Access Compliance Report Public Rights-of-Way (Curb Ramps)

Main Street: LULLABY_CIR Cross Street: MELODY_LN Location: E

ADA ID: RPRK211027132053 Ramp Type: Type 4 - Parallel Initial Pass/Fail: Fail Overall Compliance: No Severity Score: 2

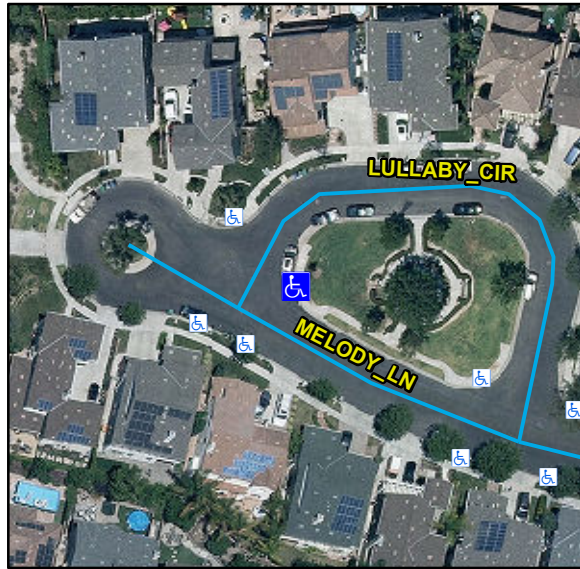
Compliance	Description	Data	Compliance	Description	Data
N/A	Ramp Length LT (in)	119	N/A	Ramp Length RT (in)	104
Yes	Ramp Width LT (in)	53	Yes	Ramp Width RT (in)	53
Yes	Ramp Run Slope LT (%)	0.3	Yes	Ramp Run Slope RT (%)	6.5
Yes	Ramp Cross Slope LT (%)	1.4	No	Ramp Cross Slope RT (%)	2.8
N/A	Landing Present	N/A	N/A	DWS Provided	N/A
N/A	Landing Length (in)	N/A	N/A	DWS Contrast	N/A
N/A	Landing Width (in)	N/A	N/A	DWS Length (in)	N/A
N/A	Landing Run Slope (%)	N/A	N/A	DWS Full Width	N/A
N/A	Landing Cross Slope (%)	N/A		DWS Offset Type	N/A
N/A	Landing Movement Obstructed?	N/A	N/A	DWS Offset Left (in)	N/A
	Landing Movement Type	N/A	N/A	DWS Offset Right (in)	N/A
N/A	Landing Shared	N/A			
N/A	Clear Space	Yes			
N/A	Clear Space To Crosswalk (in)	N/A			
N/A	Marked Crosswalk 1	No	N/A	Marked Crosswalk 2	No
	Crossing 1 Direction	NW		Crossing 2 Direction	SW
N/A	Marked Crosswalk 1 Width (in)	N/A		Marked Crosswalk 2 Width (in)	N/A

Remove & Replace Curb Ramp With Two New Directional Ramps or Equivalent.

R204.3, R304.5.3, STD 1115
